TECHNICAL BULLETIN

X303-61v2

FUEL VAPOR FUMES ENTERING THE VEHICLE CABIN

Model: XK Convertible (North America and Canada Markets Only)

Fig. 1

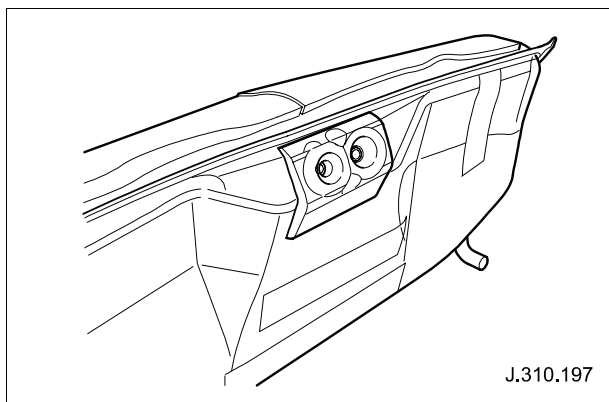
12 Ensure the existing fuel tank to body seal is correctly positioned over the fuel tank return outlet (see Fig. 1).

Fig. 2

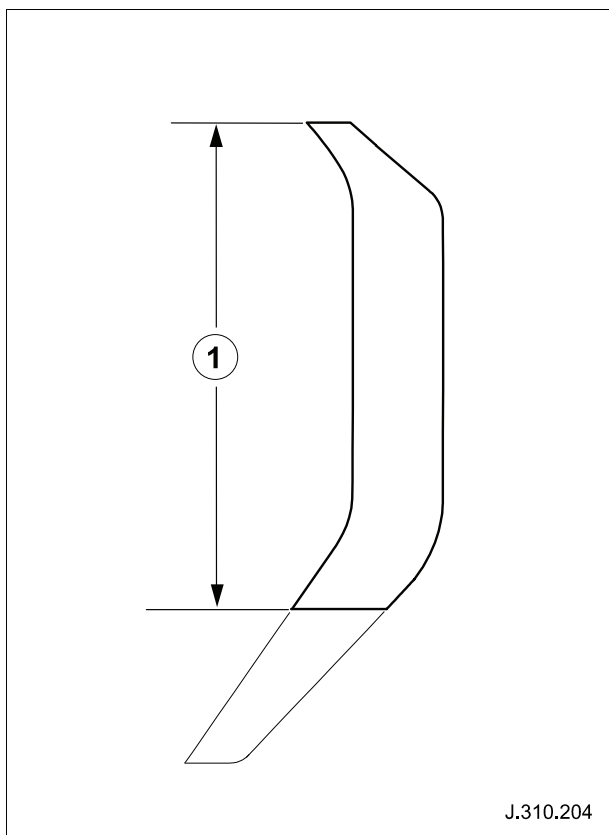
13 Place new fuel tank to body seal to front, measure and mark the position (1) for the cut on the new seal (74.5mm from the short lip see Fig. 2).

Fig. 3

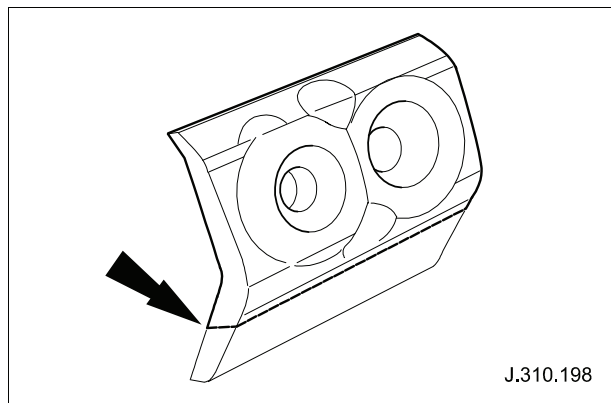
- 14 Using a suitable sharp bladed tool and straight edge, cut and remove portion of the new seal (see Fig. 3).

Fig. 4

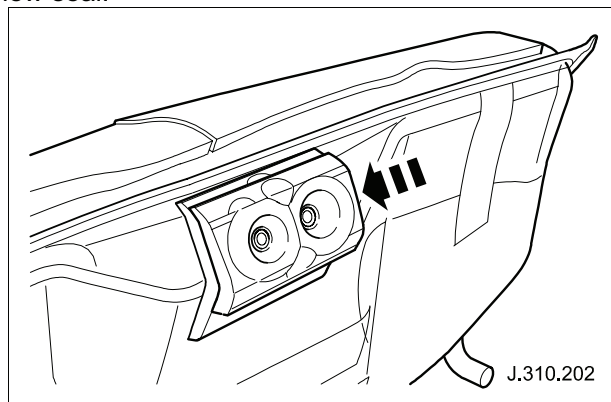
- 15 Remove and discard backing paper from the new seal.
16 Align and install the new cut down portion of the seal onto the existing fuel tank to body seal (see Fig. 4).

Fig. 5

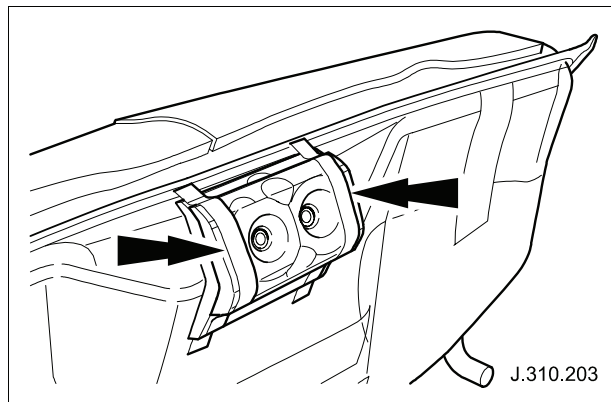
- 17 Using suitable adhesive tape, secure both seals at each end (see Fig. 5).

Fig. 6

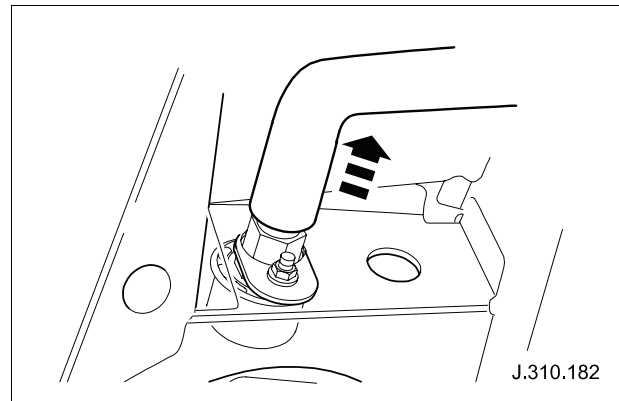
- 20 Disconnect the EVAP canister vent hose from the original filter (see Fig. 6).

Fig. 7

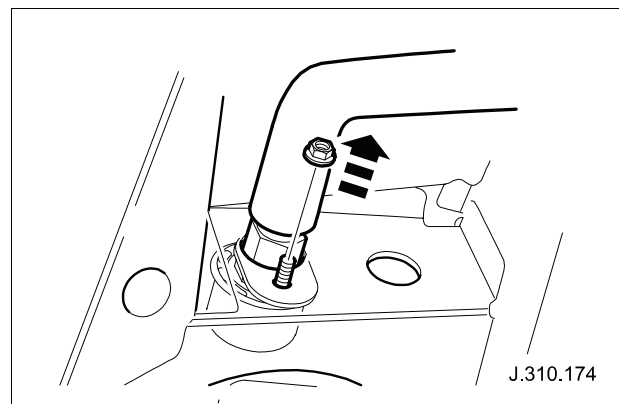
- 34 Assemble new filter and bracket.
 Undo and remove original filter securing nut (see Fig. 7).

Fig. 8

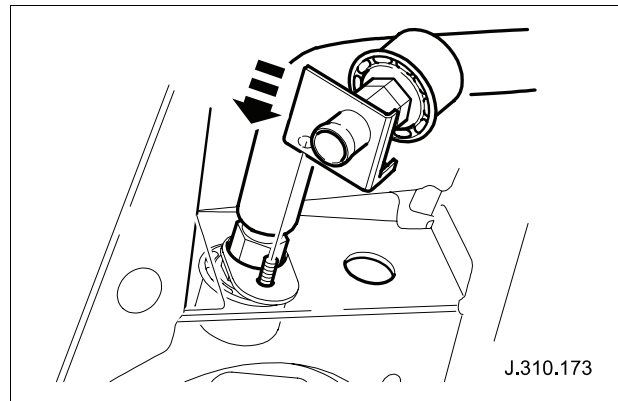
- 35 Holding original filter in place by hose, install new filter/bracket assembly to old filter stud (see Fig. 8).

Fig. 9

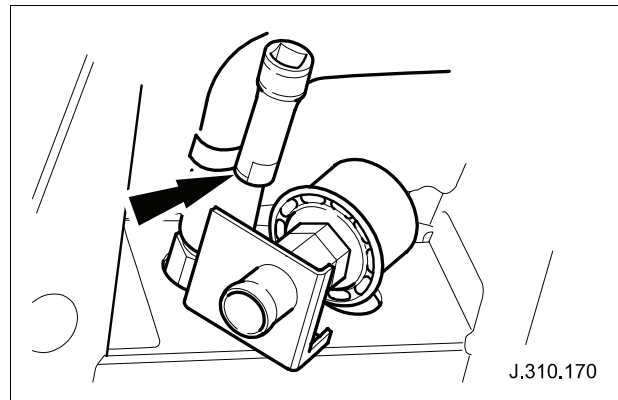
Note: To aid operation, secure nut to a deep socket with masking tape (see Fig. 9).

Fig. 10

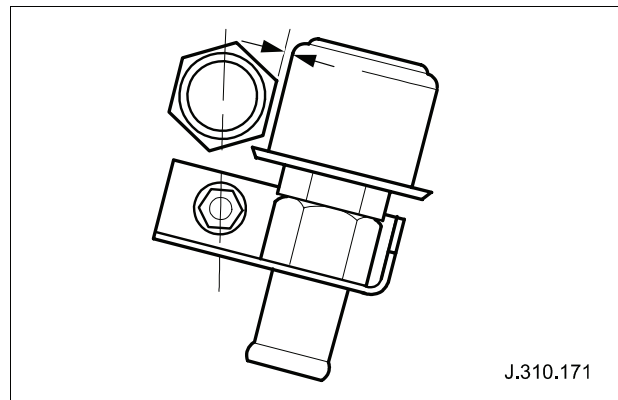
- 37 Remove and discard original filter vent hose.
38 Align new filter body to give approximately 1mm clearance from original filter stub pipe (see Fig. 10).

Fig. 11

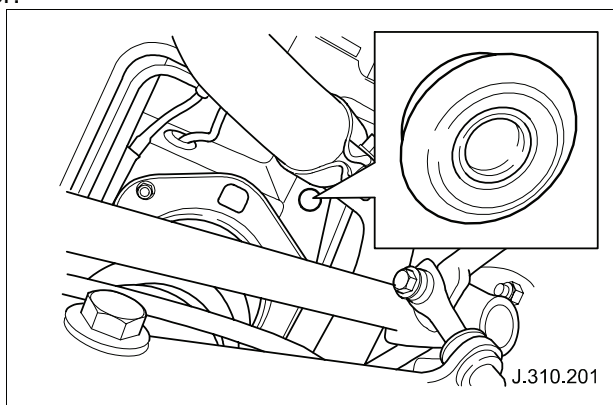
- 51 Secure vent pipe to plastic body clips.
 52 Connect EVAP canister vent hose to new filter.
 53 Install new blanking plug to the left hand side rear road spring turret (see Fig. 11).

Fig. 12

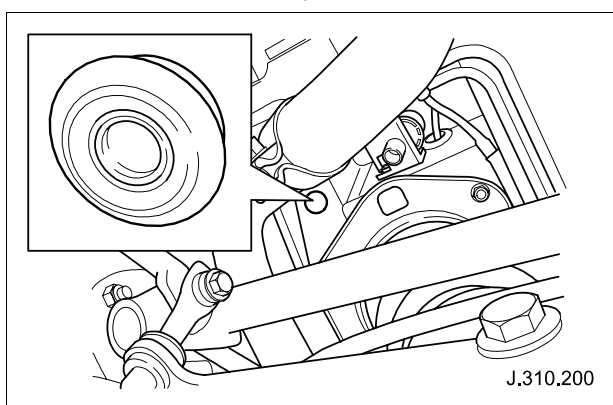
- 54 Install new blanking plug to the right hand side rear road spring turret (see Fig. 12).
